INTERNATIONAL STANDARD ISO 14520-1:2006/Cor.1:2007(E)
TECHNICAL CORRIGENDUM 1

Gaseous fire-extinguishing systems — Physical properties and system design —

Part 1: General requirements

TECHNICAL CORRIGENDUM 1

Figure C.7 — Pan geometry for Wood crib and Heptane pan fire test

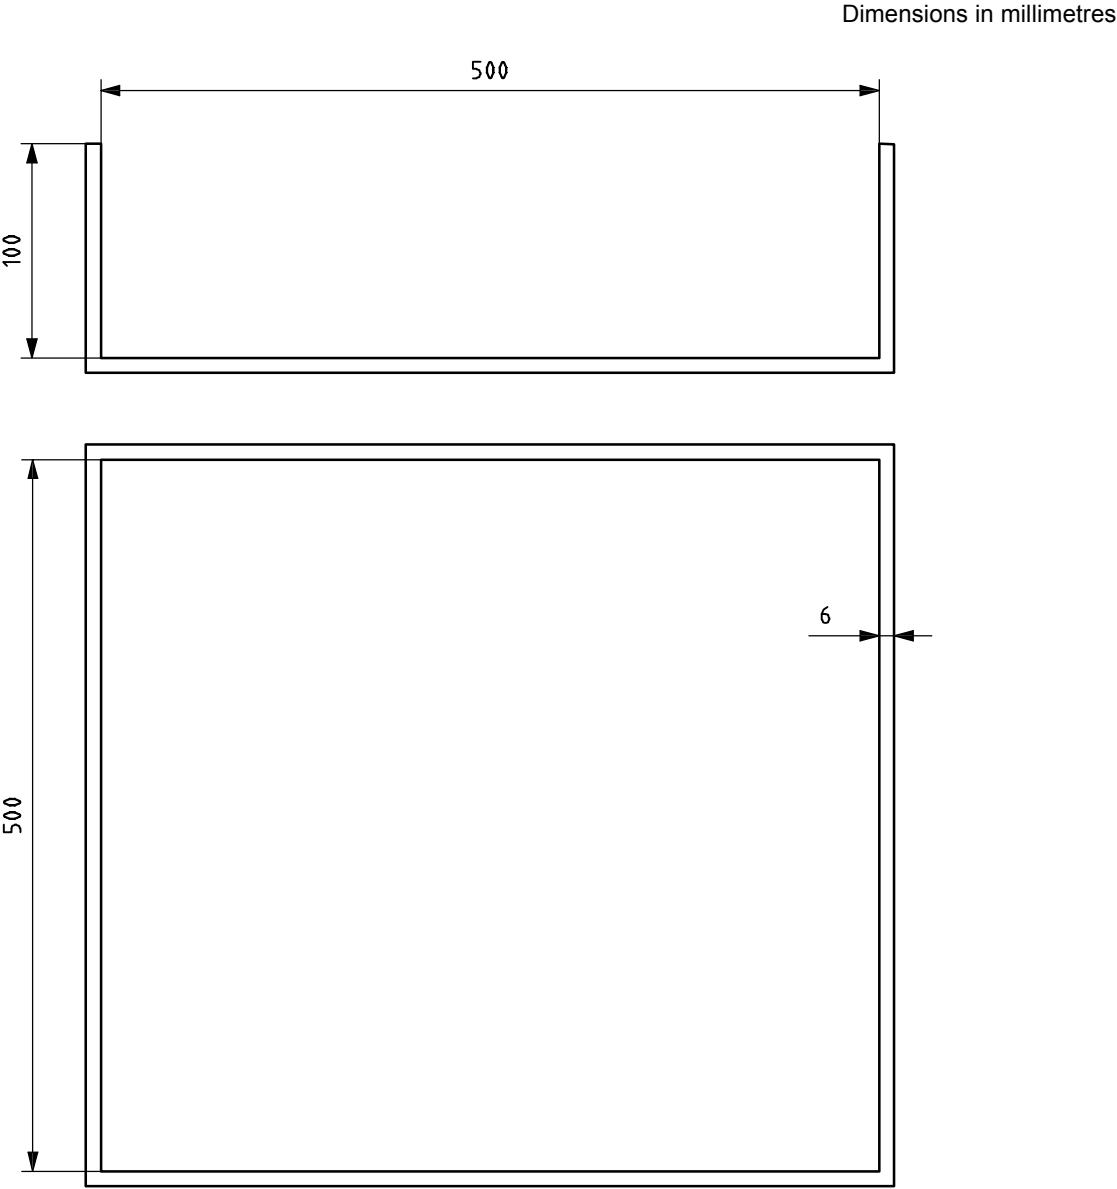
Page 50, C.6.1.2.2:

Replace Figure C.7 with the following, showing the correct 100 mm inner dimension.
